File 1977-0092

Project Name: 6 & 50 West

Final Plat - 6850 West

Subdivision Preliminary Plat - 6#50 West Sub.

PRELIMINARY PLAT OF SIX & FIFTY WEST SUBDIVISION

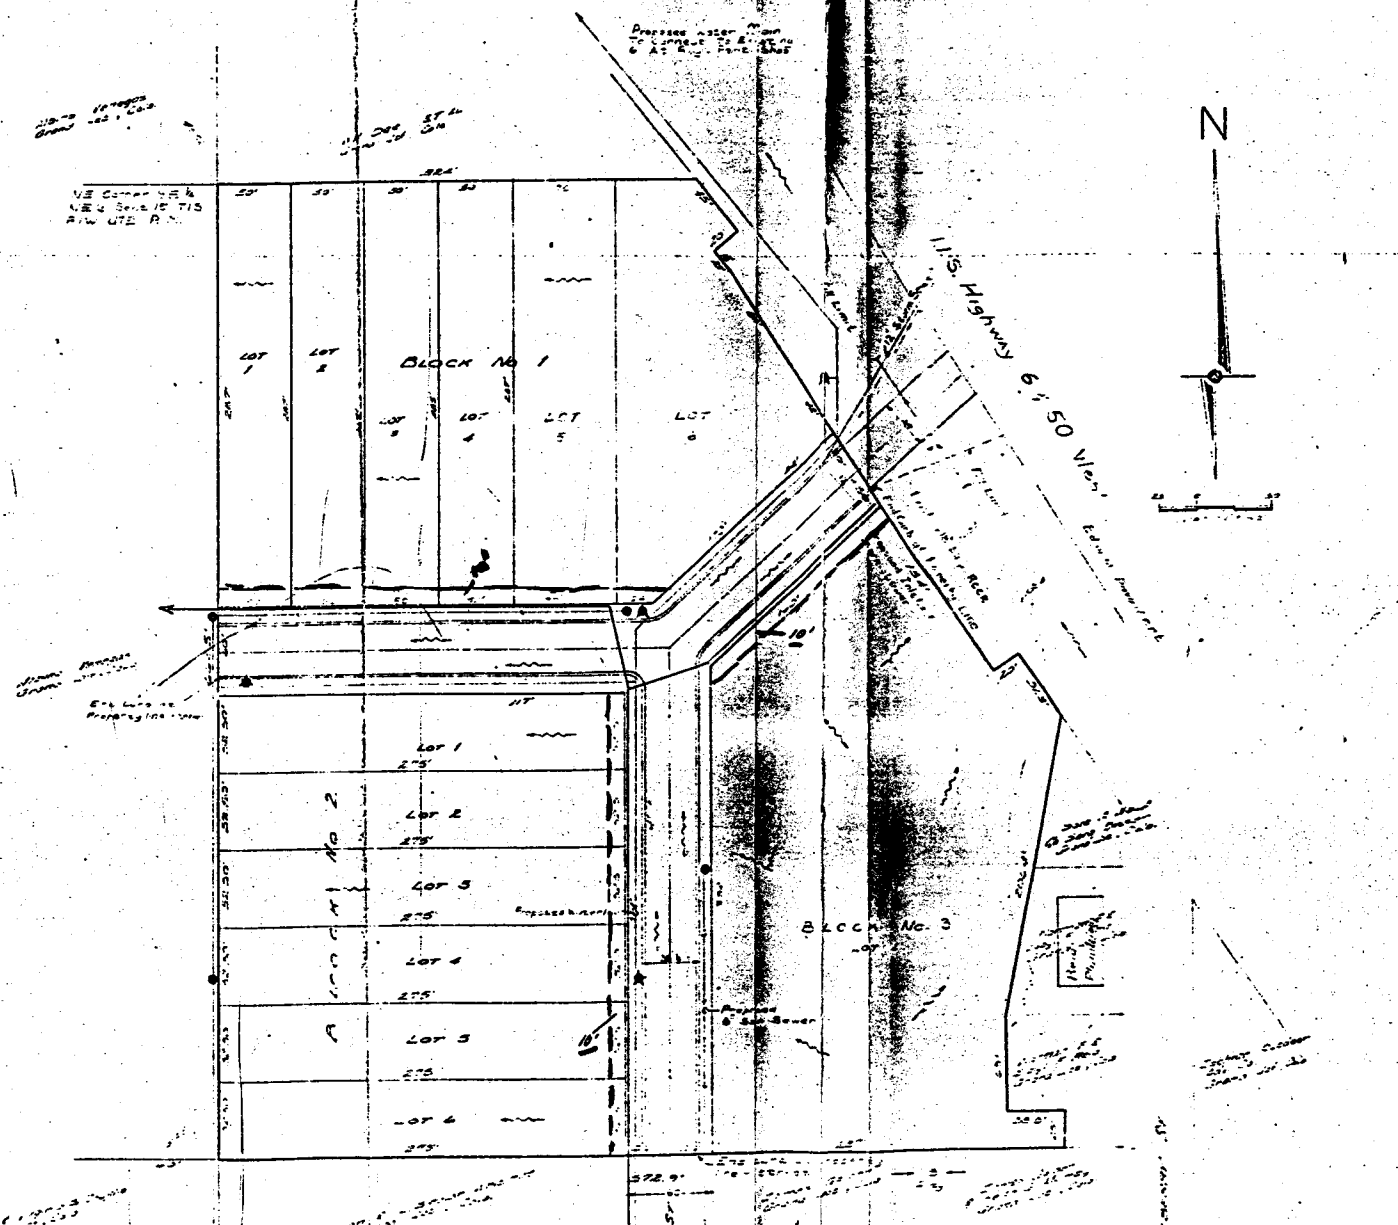
① Fire Dept. - NOT less than 8" looped water mains. Water supply to this area must be upgraded. Move hydrant shown on Peach to SE Cor lot 6).

Dislike access as shown. Dev. to work with CHD on improving access.

② City Utilities - city may wish to participate in oversizing water lines.

③ Public Service - electric - require 10' easement abutting North + West property lines.

② Mrs Bell - add'l easement required.

*④ City Eng. - need 41' mat. w. STD vert. face C, G. & Side

Indicate outlet for Storm Drainage.

Temp. cul de sac on West End of West Garrison

Improved access.
